FINAL ENVIRONMENTAL ASSESSMENT

**RECONSTRUCTION OF A FAILING RETAINING
WALL AT 46-035 LILIPUNA ROAD
Kaneohe, Oahu, Hawaii**

Department of Planning and Permitting:

Figure 3 Revised : Original Site Topographical Survey

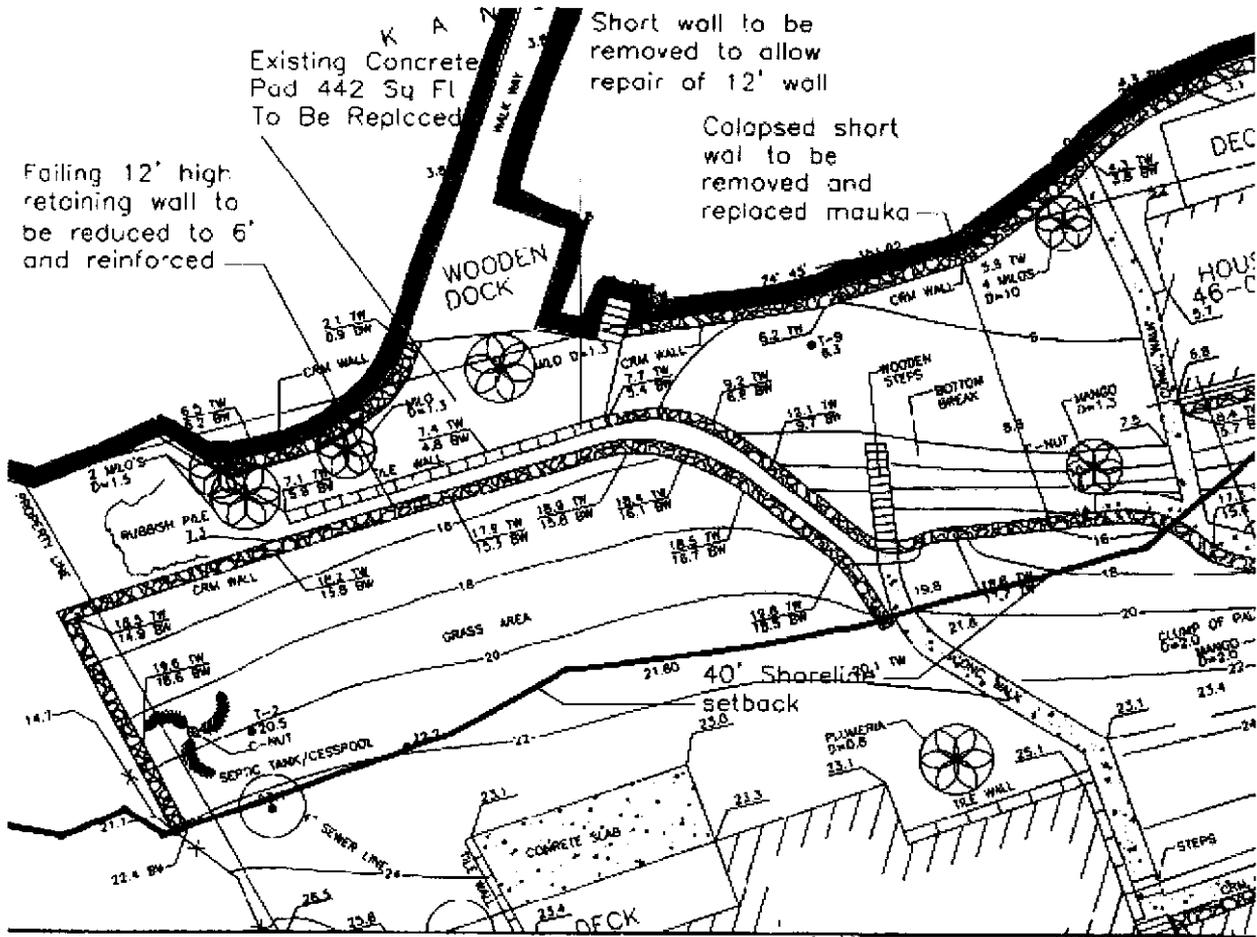
1. The 40-foot shoreline setback line depicted in Figure 3 "Site Topographical Survey" on page 8 of the DEA is inaccurate. Please revise the drawing to reflect that **every point** of the shoreline setback line is at least the required distance from **every point** at the shoreline as stipulated in Section 13-1 "Distance from the shoreline" of the department's rules relating to shoreline setbacks and the special management area (e.g., the setback line should not be so "angular").

1. "The 40 ft. shoreline setback line in the DEA is inaccurate,"
The basis of the setback line in the DEA was to move the approved "surveyed" shoreline in the mauka direction 40 ft. This included the irregularities in the shoreline survey line as it was drawn around various protrusions into the ocean. We have smoothed out these protrusions to hold at least 40 feet from all points as stipulated. See attached exhibit Revised Figure 3. This will replace Figure 3 in the final EA.

Figure 9: Original Engineering Design Section

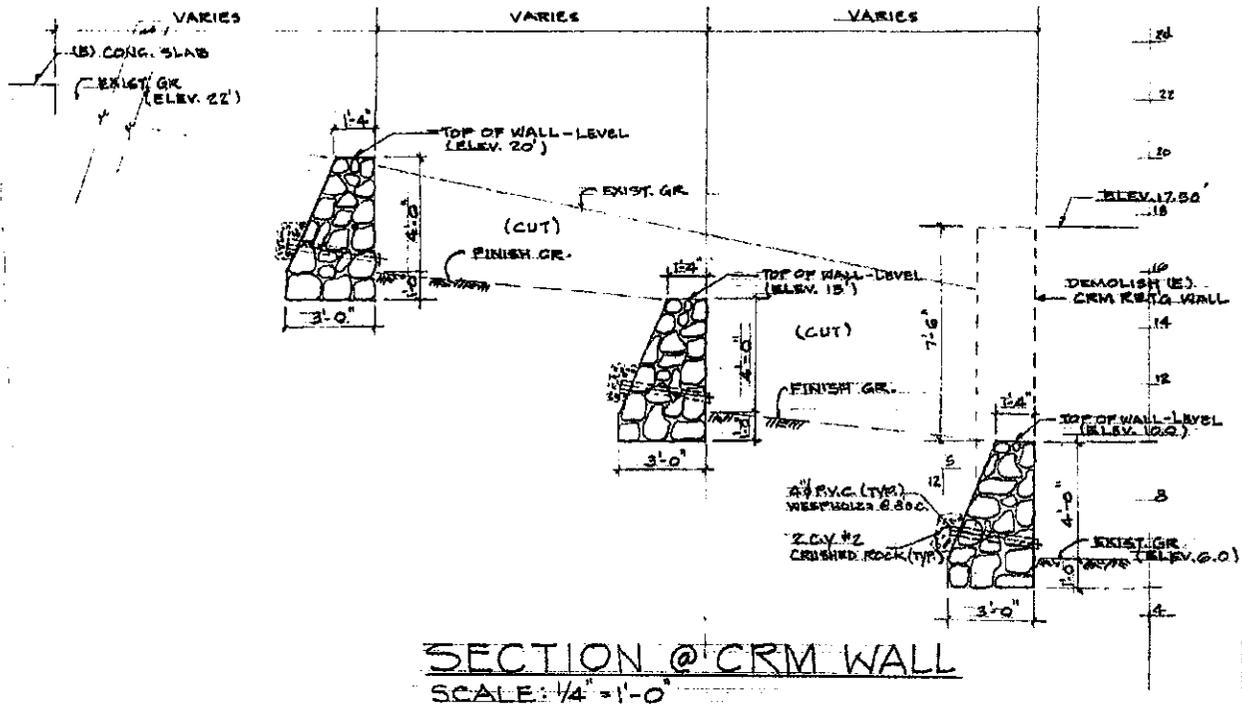
2. Please address coastal/shoreline views from Lilipuna Road under Section 2, Description of the Affected Environment of the DEA.
3. It is not clear whether the grades depicted in Figure 9 "Engineering Design Section" of the DEA are grades as they currently exist or as they previously existed prior to the mass grading work (e.g., does the "existing grade" reflect the grade that currently exists?). We recommend two separate section drawings: one depicting previous conditions (before mass grading) and the other depicting existing conditions.

3. "Clarify the grading shown on Figure 9."
You are correct. The grading lines shown on the engineering section shows the existing grading prior to the start of the project and the intended finished grading. Circumstances have evolved since this design was drawn, i.e., the upper two walls were built, the existing wall was reduced in height and reinforced, and the soil was removed. Therefore, the finish grade shown on the drawing is now the existing grade. See attached Figure 9A. We will keep the original Figure 9 as the original engineering concept and add a figure 9A as the existing condition showing completed work and grades.
